Access Compliance Report

Public Rights-of-Way

Intersection ID: 42798	Main Street: CRIMSON_SARGENT_DR	Cross Street: LADY_CLARE_DR	Location: SW
ADA ID: BA0C05553EC8	Ramp Type: PerpDiag	Initial Pass/Fail: Fail	Overall Compliance: No
Severity Score: 21.25			
Codes/Mitigation Info/Possible Solution		Field Measurements/Component Compliance

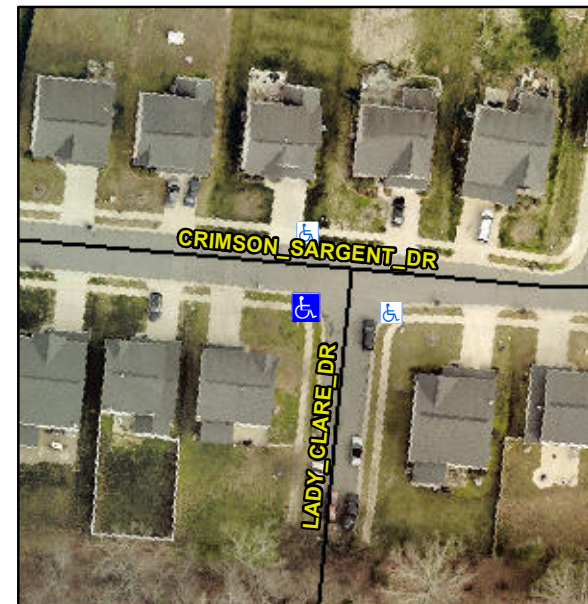
Not Found, R304.5.1, R304.2.2

Compliance	Description	Data	Compliance	Description	Data
N/A	Ramp Length (in)	48.5	No	Ramp Slope (%)	11.3
No	Ramp Width (in)	47.0	Yes	Ramp XSlope (%)	1.5
N/A	Flare Type LT	N/A	N/A	Flare Type RT	N/A
N/A	Flare Slope LT (%)	N/A	N/A	Flare Slope RT (%)	N/A
N/A	Flare Traversable LT?	N/A	N/A	Flare Traversable RT?	N/A
N/A	Landing Length (in)	N/A	N/A	DWS Provided?	N/A
N/A	Landing Width (in)	N/A	N/A	DWS Contrast?	N/A
N/A	Landing Slope (%)	N/A	N/A	DWS Length (in)	N/A
N/A	Landing X Slope (%)	N/A	N/A	DWS Full Width?	N/A
N/A	Landing Curb? (Y/N)	N/A	N/A	DWS Offset (in)	N/A
N/A	Shared Landing?	N/A			
N/A	Gutter Ponding?	N/A	N/A	Gutter Slope (%)	N/A
N/A	Gutter Lip Ht (in)	N/A	N/A	Gutter X Slope (%)	N/A
N/A	Painted X Walk1?	No	N/A	Painted X Walk2?	No
	X Walk 1 Direction	To E		X Walk 2 Direction	To N
N/A	X Walk 1 Width (in)	N/A	N/A	X Walk 2 Width (in)	N/A
	X Walk 1 Slope (%)	1.9		X Walk 2 Slope (%)	2.0
	X Walk 1 X Slope (%)	0.3		X Walk 2 X Slope (%)	2.9

Remove & Replace Curb Ramp With Two New Directional Ramps or Equivalent.
